#### POTENTIALLY UNQUALIFIED COMPONENT IN CERTAIN ALLEN BRADLEY TIMING RELAYS

"Report of potential 10 CFR Part 21, Allen Bradley Timing Relay Model 700RTC

**UPDATE** - Report of potential 10CFR Part 21, Allen Bradley Timing  
Relay Model 700RTC  
Report No: P21-04302015, Rev. 1

Part 21 Report No: P21-04302015, Rev. 1

Figure 2 - New design circuit board and CPLD that replaced the original component.

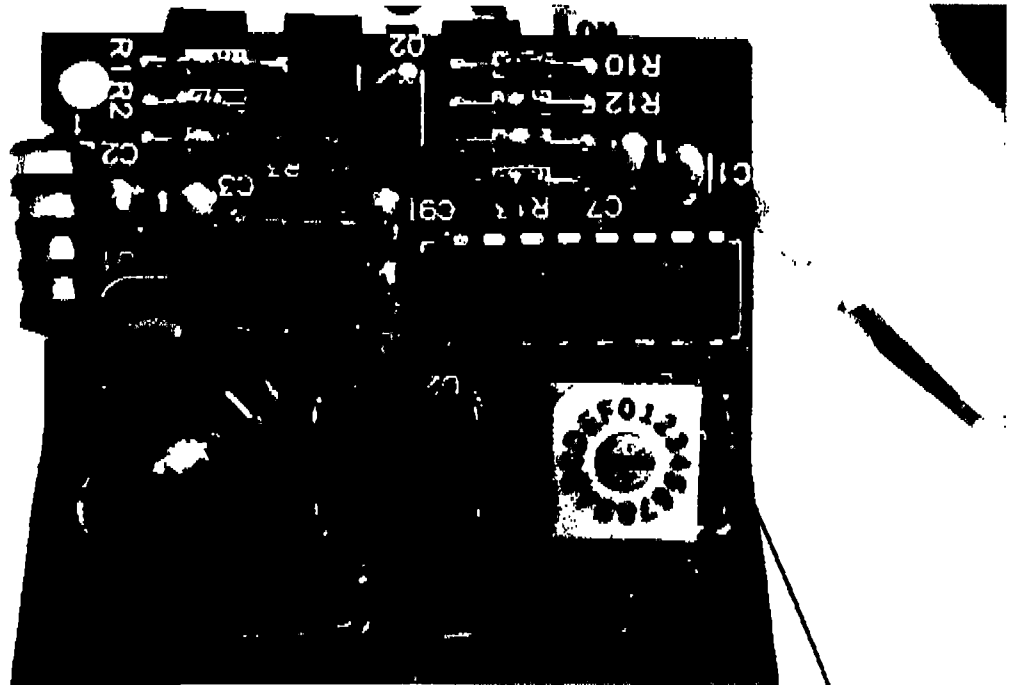
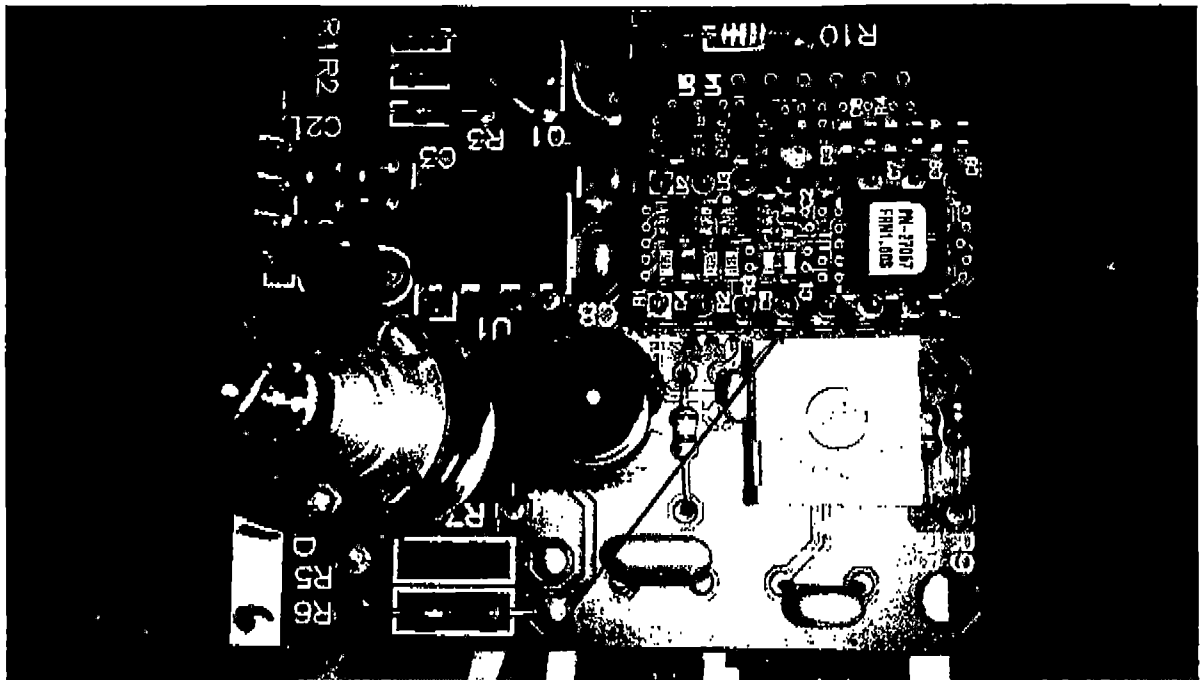
As of 2009-2010, Allen Bradley relays base model 700RTC, contain an unevaluated CPLD (Complex Programmable Logic Device). This was an unpublished design change that was implemented to replace an obsolete integrated circuit chip. The undocumented design change did not result in a part number change from Allen-Bradley. There was no change to the appearance of the relay that would identify any design changes were made to the relay configuration.

Between 2009-2010, Allen Bradley made a design change without changing the part number of the commercial relay or providing any documented evidence of a design change. The manufacturer specification data sheets maintain the classification that the relays are "solid state", which would imply that there are no digital devices installed in the relay. However, after inspection of the internals of the timing relay (Figure 2), it has been identified that the unit does contain a CPLD which meets the definition of a digital device under the guidance of NEI 01-01. See Figures 1 and 2 below:

The relays that are currently in stock at NLI have been placed on hold until after the units have been determined to be qualified for the specific application. NLI has completed the EMC qualification testing per the requirements of EPRI TR-102323 Rev. 3 for the following tests, as applicable: CE101, CE102, RE101, RE102, RS101, RS103, CS101, CS114, CS115 and CS116.

The results were satisfactory with exception of the following condition: During Conducted Susceptibility CS114 onto the power lines, with the timing circuit in operation, the timing contacts exhibited chatter in the range of 2.6 MHz to 20.3 MHz. The unit requires a ferrite to be installed onto the input power lines of the relay with 3 turns through the ferrite core. In this modified configuration, the relay was not susceptible to Conducted Susceptibility and successfully passed the required test per CS114.
